**1 Products affected**

Change of material, V-Lock cord retaining feature as standard.

Product Change Notification					PCN 4798		
owner	creation date	release date	released by	change order no	rev	page	0118.2322
hotzar	2015-12-05	2016-03-14	stadelt1	2009470	A	1 of 2

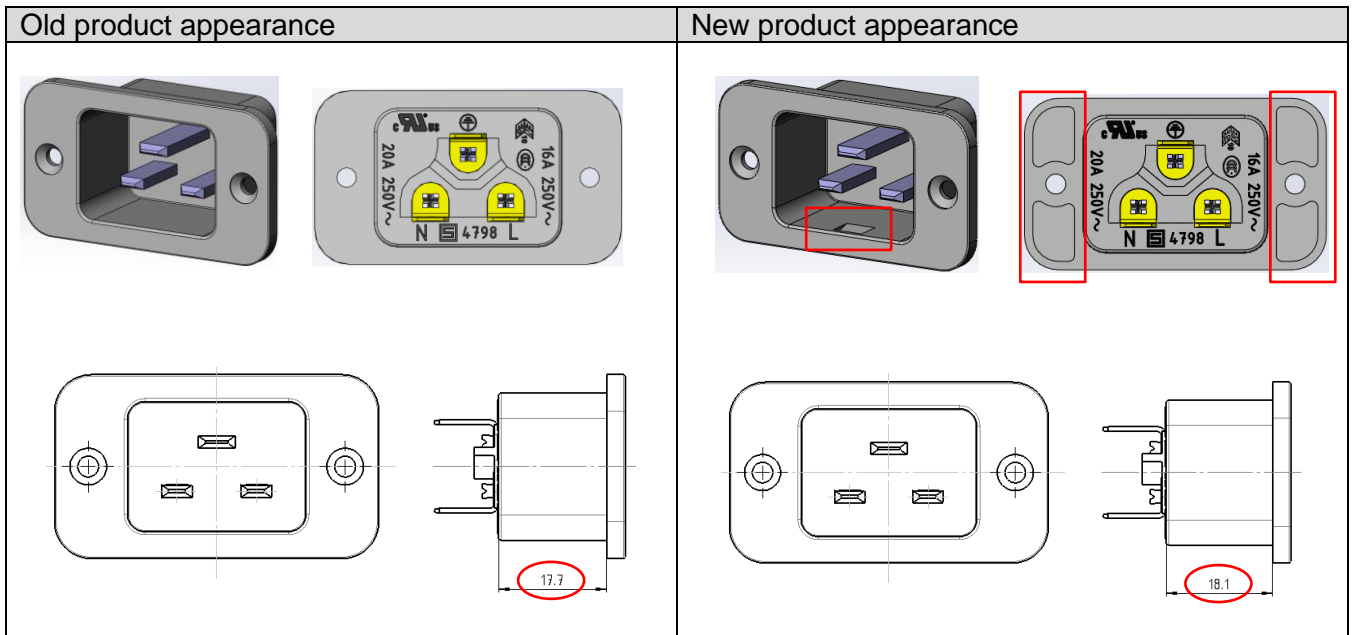
- Material change from PA6 to PA66/6 to pass the enhanced requirements of glow wire test acc. to IEC 60695-2-12 and -13
- V-Lock feature integrated as standard (not an option anymore)
- Flange will have a new form on the back side to improve molding process.

Form	Yes	Yes Socket has notch for V-Lock cord retaining, flange new form on the back side, extended socket dimension.
Fit	Yes	Yes, installation depth is 0.4 mm extended.
Function	Yes	V-Lock feature is standard (not an option anymore)
Production Site	No	There is no change of the production site
Product Label	No	No label change
Customer Action	No	Check installation depth in the application. Change SCHURTER part number if affected.

4798.9000.15 ⇒ 4798.9000	4798.9100.15 ⇒ 4798.9100	4798.9200.15 ⇒ 4798.9200
4798.9000.21 ⇒ 4798.9000	4798.9100.21 ⇒ 4798.9100	4798.9200.21 ⇒ 4798.9200
